Planning Board

February 25, 2025 - 6:30 PM

4.A. Consider a recommendation on Petition #R24-11, a request by DDRTC Birkdale Village, LLC to rezone +/- 12.36 acres at 8710 Lindholm Drive from Highway Commercial Conditional District to Highway Commercial Conditional District for commercial, hotel, office and multi-family uses. (*Brian Richards*)

4.B. Consider Petition #R24-14, a request by Linda Long to rezone +/- 64.5 acres located at 12705 Commerce Station Drive from Corporate Business to Corporate Business Conditional District to develop an industrial and flex space warehouse development. (*Brad Priest*)

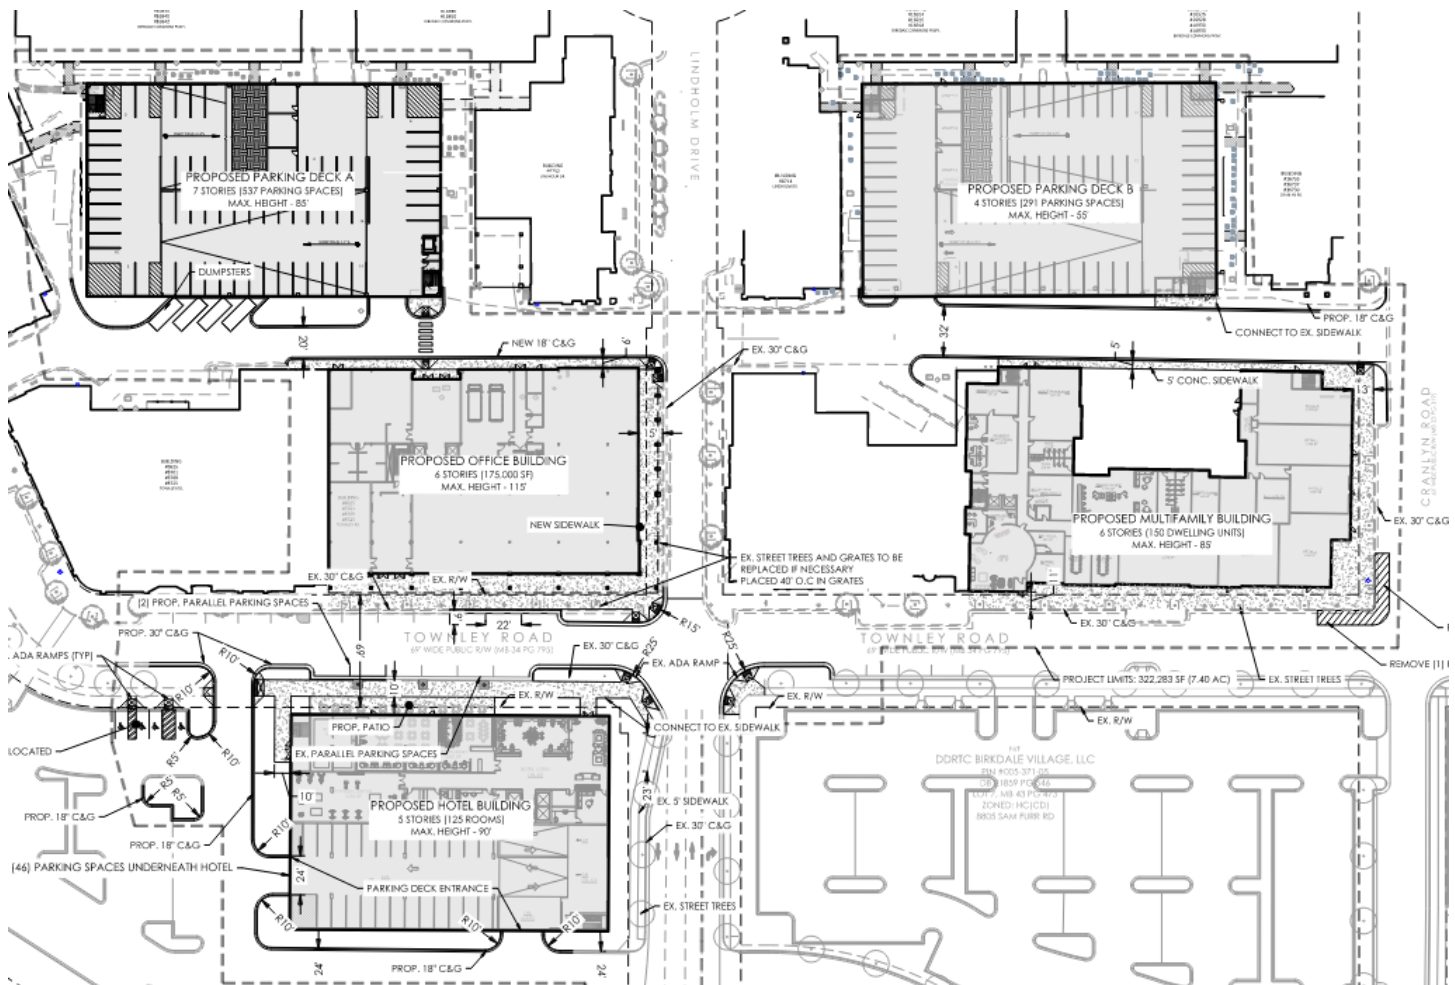
- Removal of two existing buildings and construction of three new buildings. A proposed Office (6 story, 175,000 sf, 115' height), a proposed Multifamily Building (6 story, 150 Unit, 85' height), and a hotel (5 story, 125 room, 90' height). See site plan image below. A total of 26,715 sf of Commercial will be constructed on the ground floor of these buildings.
- Replacement of Two Existing parking decks with two new parking decks. Deck A (7 story, 537 spaces, 85' height) and Deck B (4 story, 291 spaces, 55' height). There will be an overall increase of 469 parking spaces (2,409 total for Birkdale Village – 1,853 are required to meet Article 5). Currently there are 1,940 parking spaces.
- The new buildings and parking decks are requesting a modification to exceed the current height limit allowed by the Zoning Ordinance (Article 4 - Urban Workplace 48').

- Urban Open Space is being provided by the existing McDowell Creek Greenway (4.62 acres) and a Promenade (0.16 acres). There are 2.2 acres of Common Open Space. All are existing and there are no changes proposed.
- There will be no impacts to the existing tree canopy or specimen tree count as part of this rezoning.
- There are no identified Heritage Trees on site.
- Building elevations for the proposed structure have been submitted. Architectural renderings have been provided (Attachment E).
- The applicant has requested a 5-year vesting period for the Rezoning Plan. The Zoning Ordinance currently offers a 2-year vesting period (Article 2.2.3).
- Planning, Transportation, and Storm Water Engineering staff have minor rezoning plan comments outstanding that need to be addressed prior to final plan approval.

Rezoning Issues:

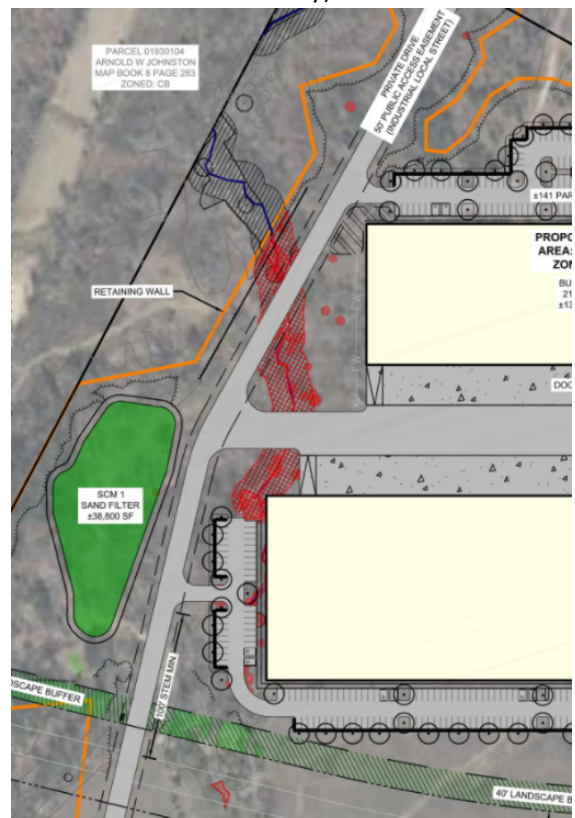
- **UPDATE 2/14/25**
 - Staff has recently released to the applicant the Town's drafted Verhoeff alternative alignments. With these updates the applicant will be able to modify their rezoning plan in an effort to accommodate the thoroughfare's potential shifts. Since they did not yet have the Town's drafted alignments no new

- **Open Space:** Article 7.11.1 C requires urban open space in all major subdivisions. No urban open space has been found on the submitted plan.
- **Conditional Notes:** The “Schematic Nature of the Rezoning Plan” note #3 on sheet C1.1 would allow extraordinary flexibility to all aspects of the conditional plan. The number of buildings, uses, street locations, lot locations, sizes, building materials etc. could all significantly change due to this note. Staff is concerned that this note nullifies the intent of the conditional plan and could allow a completely different design to be built from what was presented to the Town Board and public. Flexibility for construction after sketch plan approval is routine and to be expected, but staff recommends the note be amended to only allow “minor revisions consistent with the general layout of the rezoning plan as approved by staff”, or a variation thereof.
